SERVICE BULLETIN # 00279

SUBJECT: Incorrect Refrigerant Charge on Vender Serial Plate

MODELS: Australian RVV NG

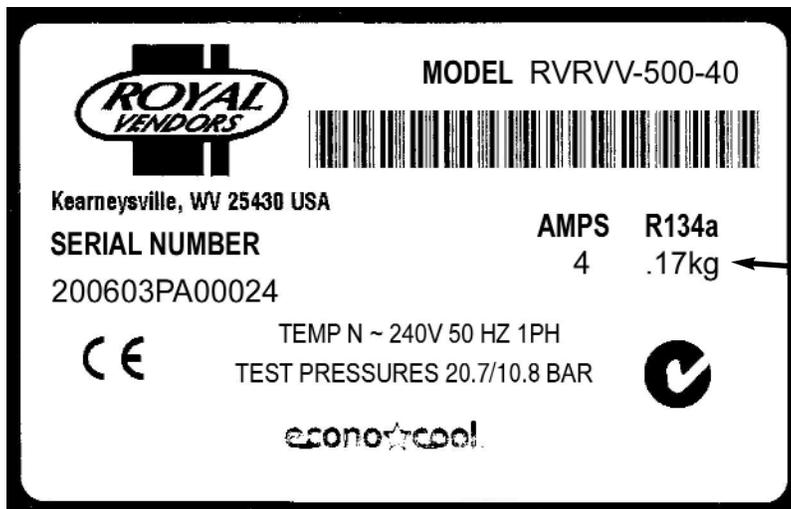
REASON FOR BULLETIN: On the vender serial plates of some RVV NG's built for export to Australia, the refrigerant charge quantity is listed incorrectly. On these units, the charge is listed as "0.17 kg" instead of the correct charge, 0.23 kg.

NOTE: There are two serial plates on the vender. One is located on the left-hand side of the door; the other is located on the kick plate of the vender's refrigeration unit. Check **BOTH** of these serial plates to ensure the correct charge is listed on them. The door serial plate is shown below.

1. Thoroughly clean the serial plate to remove all dirt, oils, etc.
2. Place the replacement decal over the incorrect charge printed on the serial plate.

Place replacement decal over the incorrect R134a charge listed on the serial plate.
